WATERLOO METRO QUARTER BUILDING 2

**SSD-10439 - RESPONSE TO SUBMISSIONS
SUPPLEMENTARY DESIGN REPORT**

This supplementary design report has been prepared to respond to Submission received for SSD-10439.

Awning Types

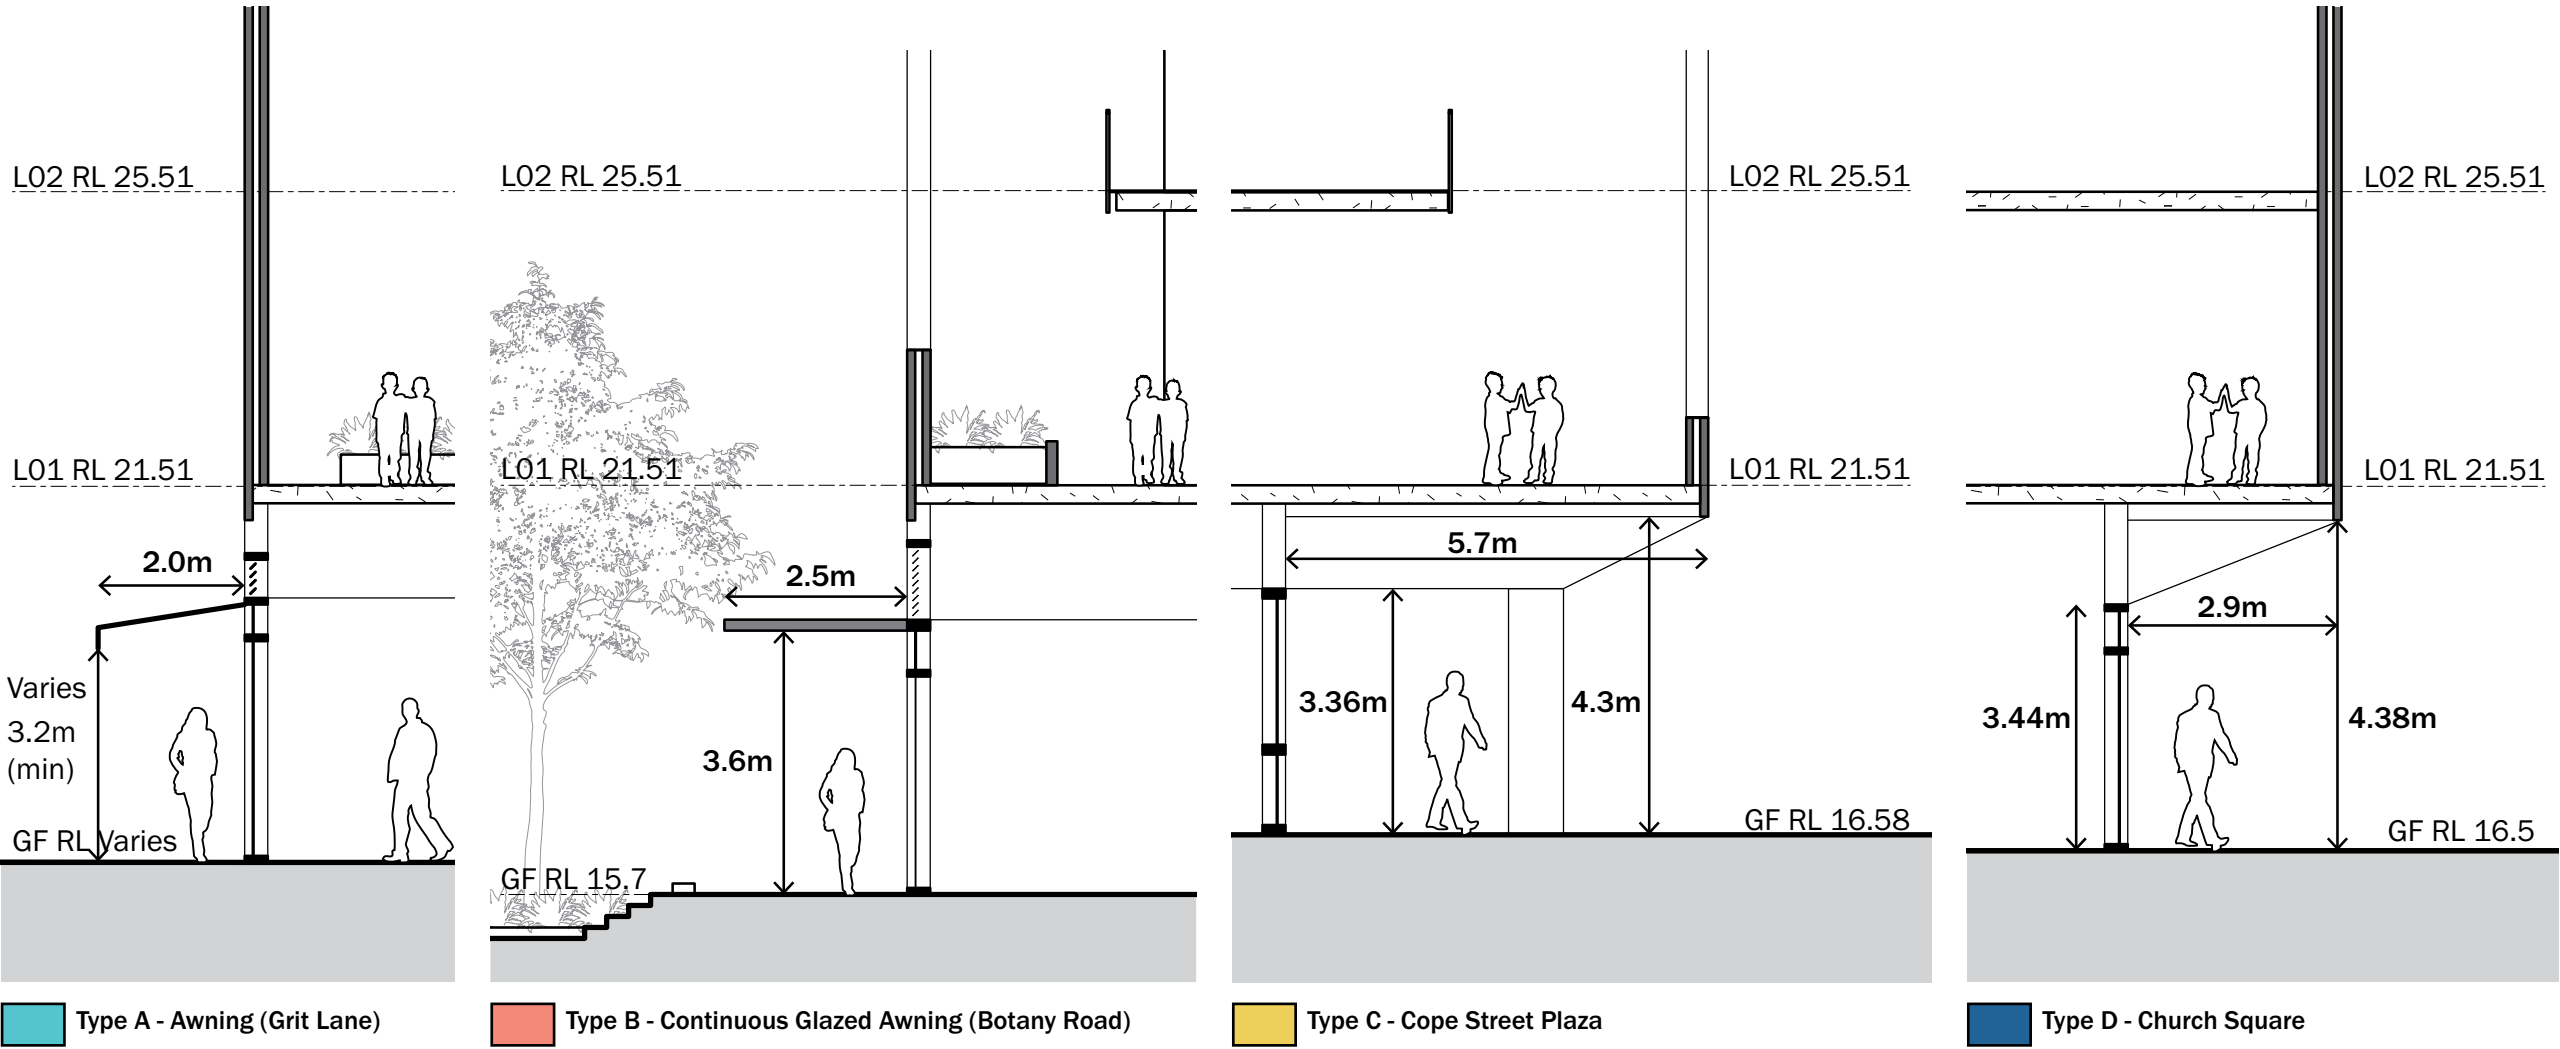
13. Awnings – The applicant and DPIE are to ensure that all awnings located over the public domain and through-site links are to be between 3.2 metres and 4.2 metres above finished ground level and to be setback a minimum 800mm from the kerb. Awning widths are to be between 2 metres and 3.6 metres whilst Remaining clear of smartpoles by 1 metre and street trees by 1.5 metres. This is to allow for under awning signage, provide suitable weather protection for pedestrians and provide sufficient clearance for vehicles, trees and infrastructure.

- _The ground plane design of building 2 incorporates a variety of awning types to provide shelter from the elements around the building. The variety of awning types is consistent with the Urban Design principles for the precinct.
- _Type A awning: a 2m deep localised awnings are provided along Grit Lane.
- _Type B awning: a 2.5m deep continuous glazed aluminium awning is provided along Botany Road to provide protection for pedestrians and retail tenancy users, as well as providing weather protection for people waiting for buses.
- _Type C awning: the podium above projects beyond the ground floor facade by 5.7m providing weather protection for pedestrians and outdoor seating zones, as well as the residential and childcare entrances.
- _Type D awning: the podium above projects beyond the ground floor facade by 2.9m providing weather protection for pedestrians and parking entry.

Typical Facade Detail Intent 1:20

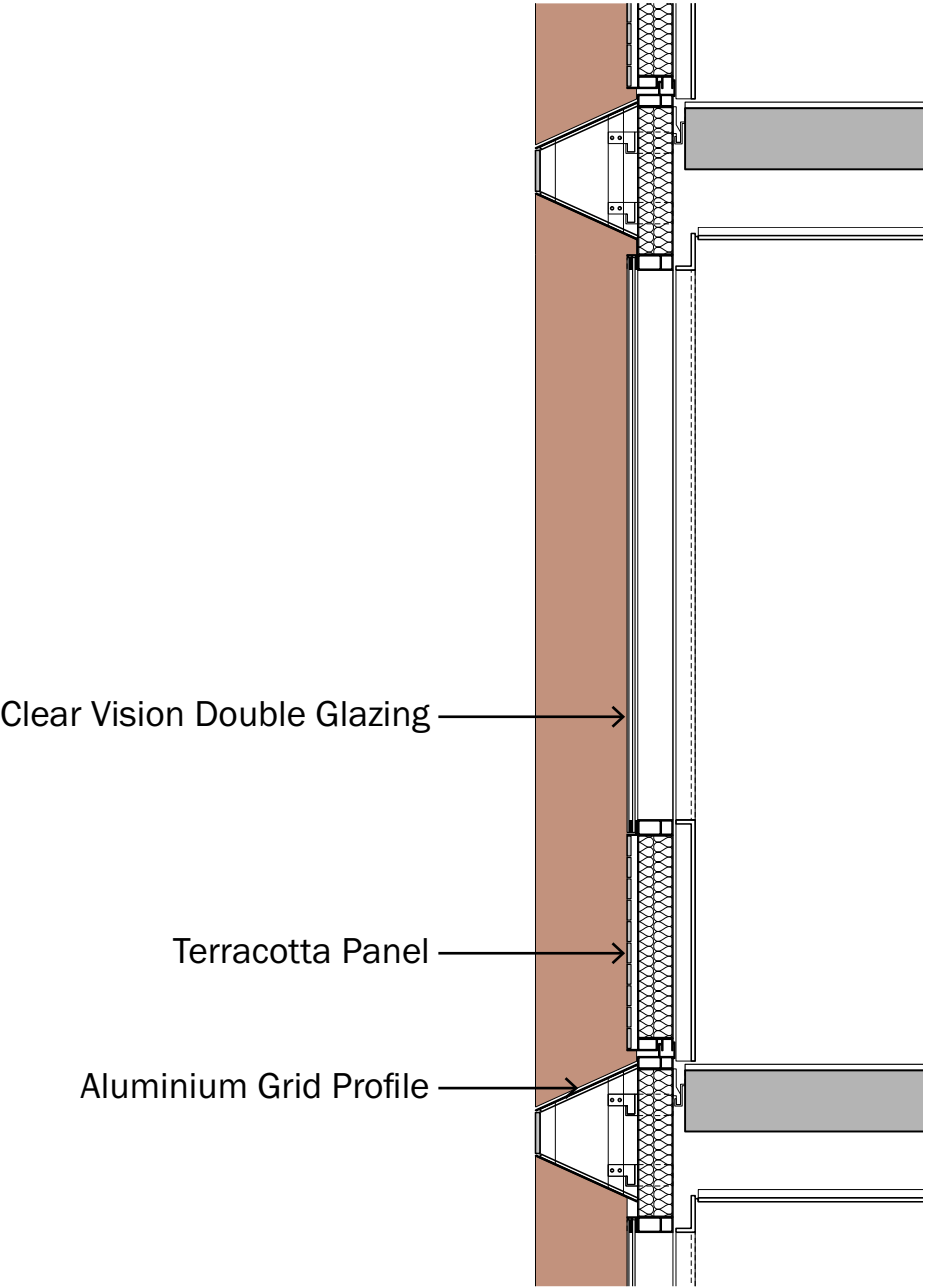
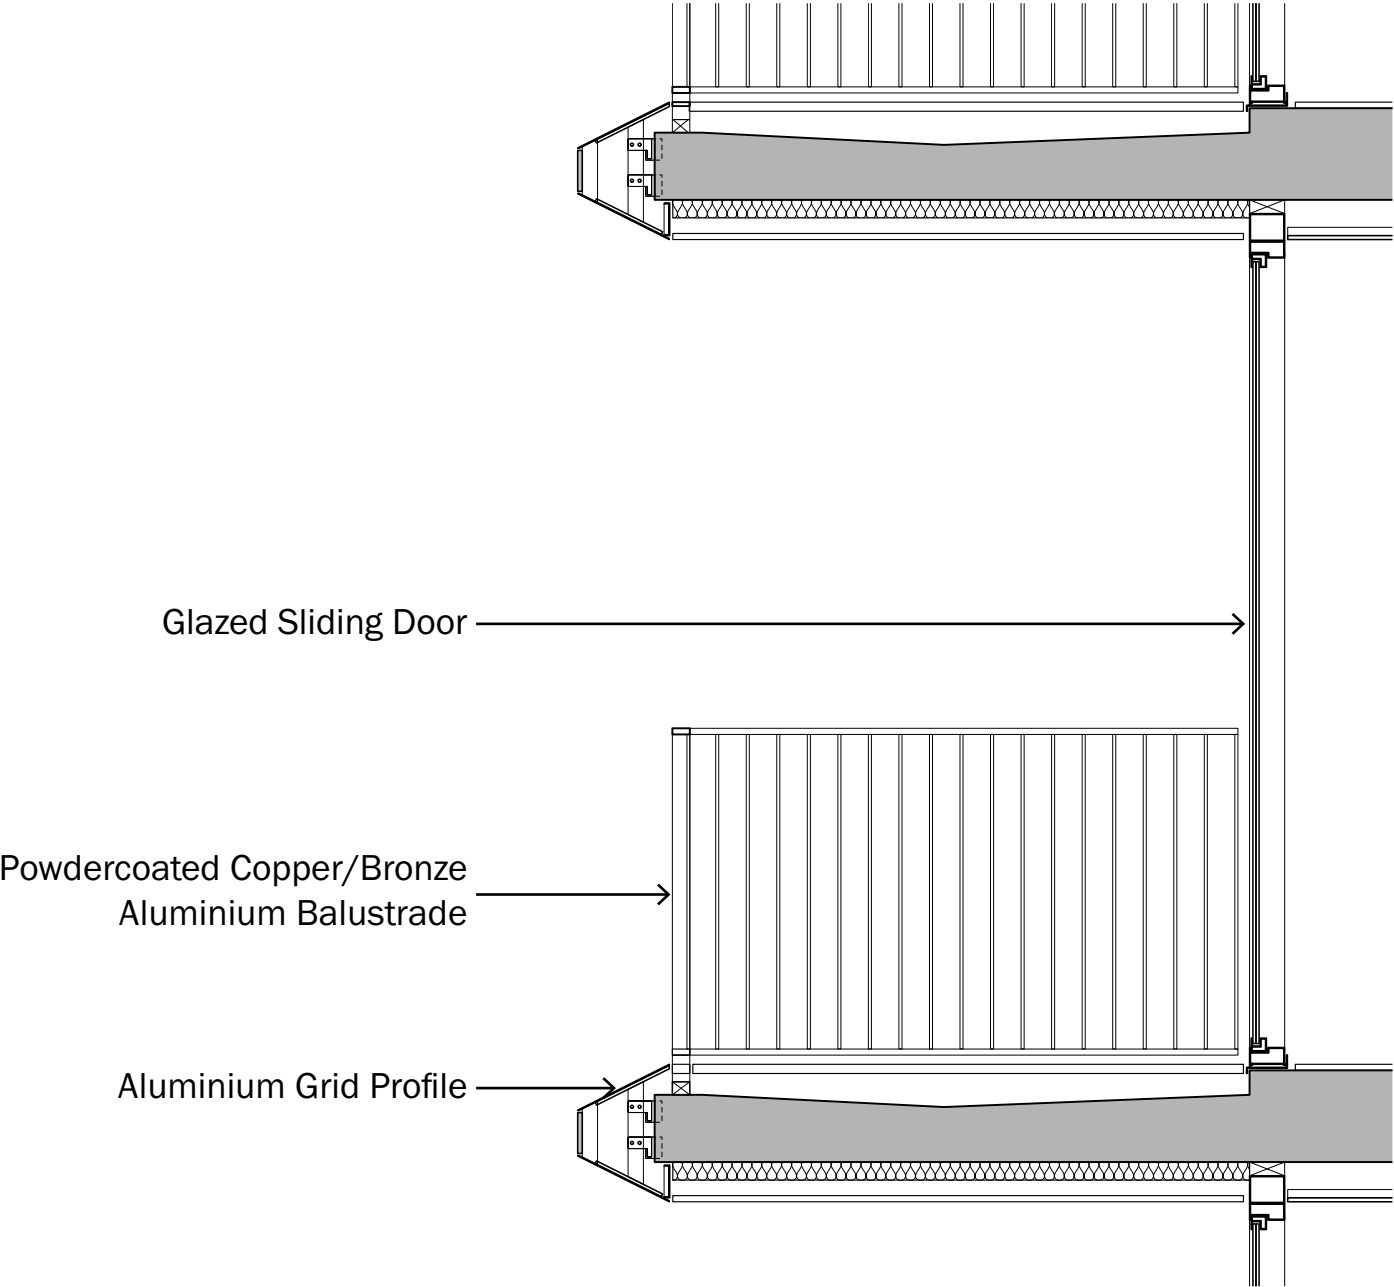
16 (a) There is a general lack of detail on facade design – 1:20 design intent facade sections should be provided to demonstrate design excellence;

_Additional details regarding tower facade detail is provided.

BUILDING 2 PODIUM FINISH

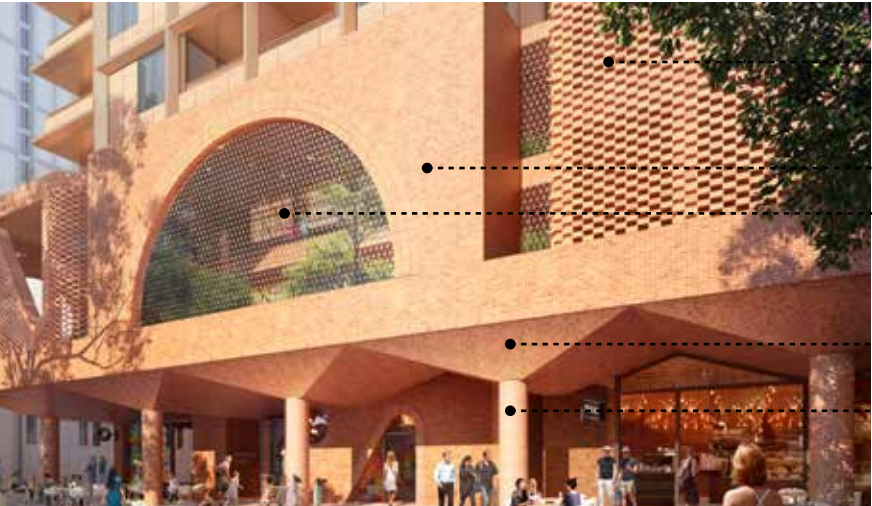
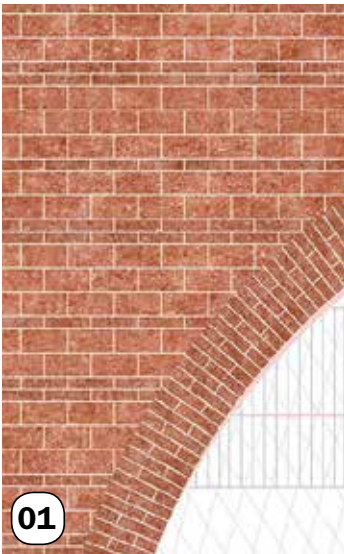
16 (b) There is a general lack of certainty or clarity of the finishes. Actual products must be specified rather than generic descriptions such as “patterned masonry facade”. References to options allowing later substitutions should be removed, e.g. “tiled or textured finish”;

16 (c) The “patterned masonry screen” referred to as MAS-02 requires more detailed information to confirm that it is suitable for the proposed use. This is a perforated screen surrounding portions of the external areas of the childcare. The reference image does not show a feasible masonry screen and the impact will be a vast reduction of available light and air through the screen. A 1:20 brickwork elevation and 1:10 plan and section details should be provided;

_Additional information regarding the proposed materials and finishes is provided.

_For MAS - 02, currently exploring 2 products (breeze block and Flexbrick) in detail design, which are both capable of delivering design intent as high quality materials, balancing both expression and amenity of the childcare within.

BUILDING 2 TOWER FINISHES

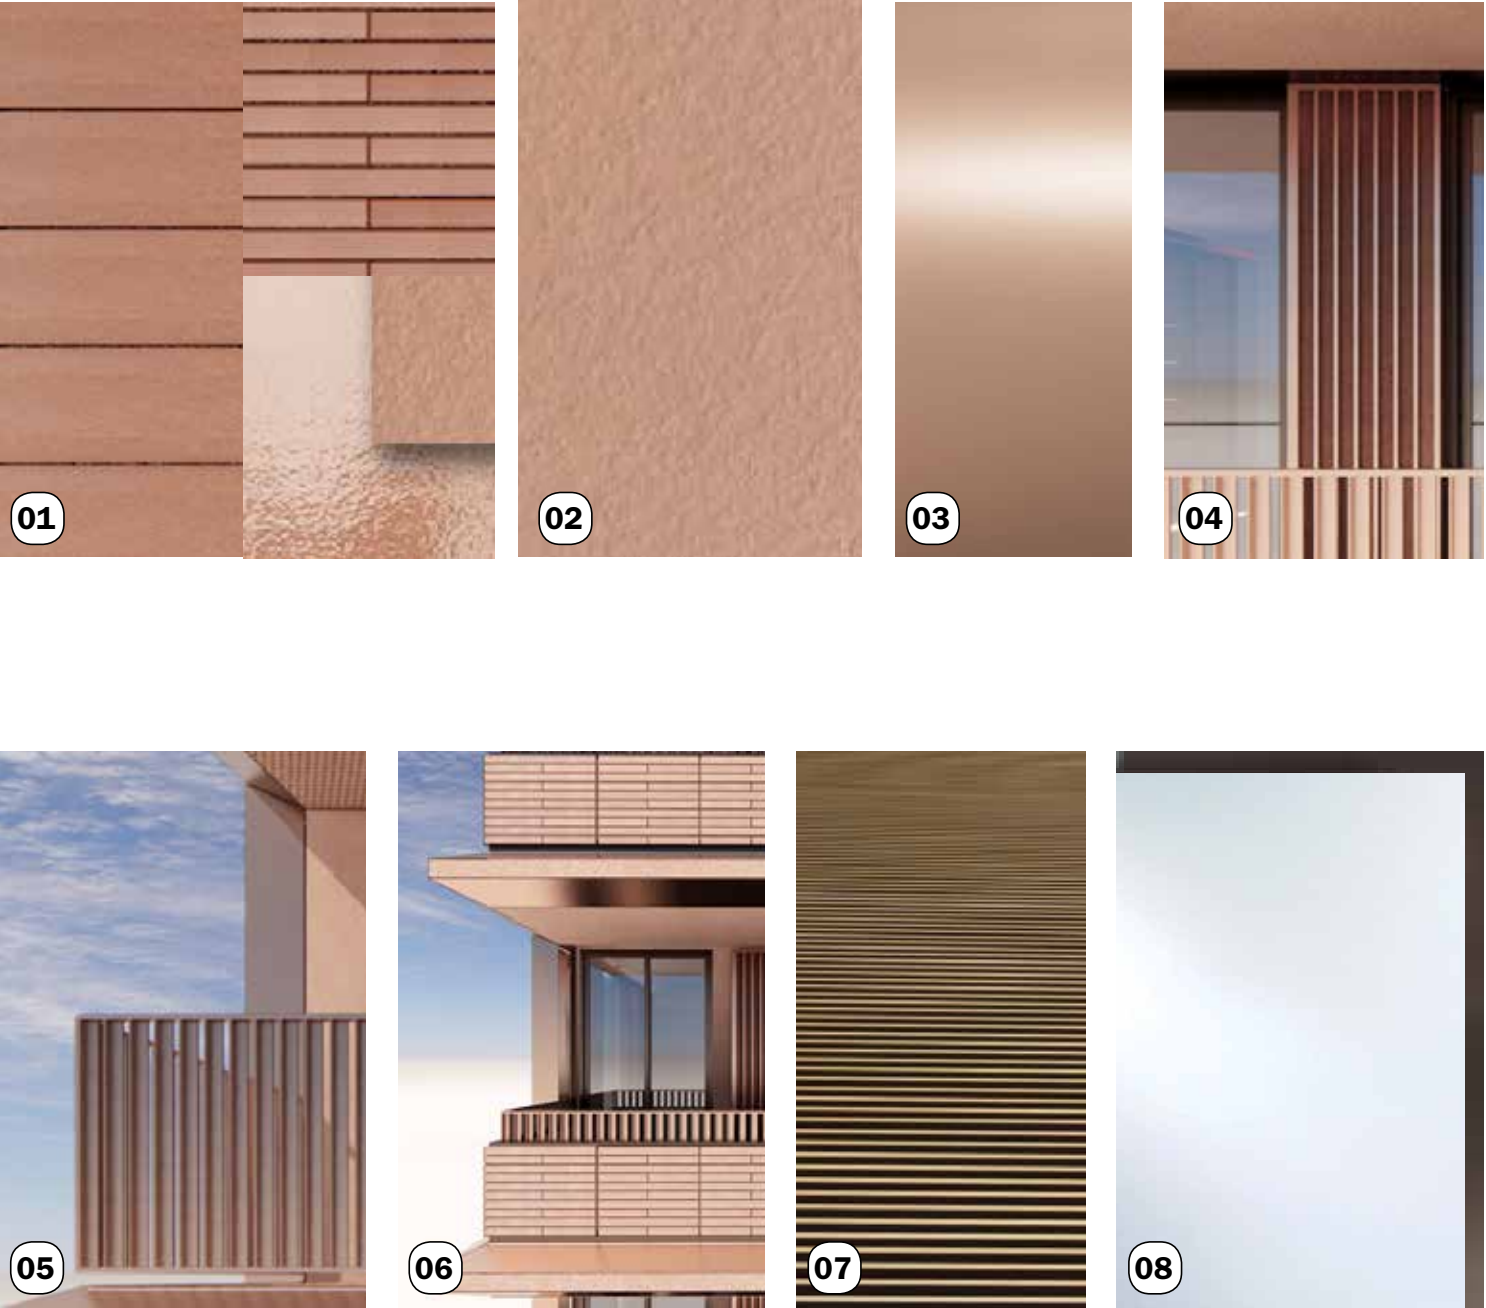
16 (e) The proposed materials for the tower are also described too generically to allow proper assessment. They appear to be lightweight cladding panels with an applied paint finish. This is not supported on the basis of design excellence. A preferred material would have an integral finish to reduce costs and effort required to maintain the finish over the lifetime of the building;

_Additional information regarding the proposed materials and finishes is provided
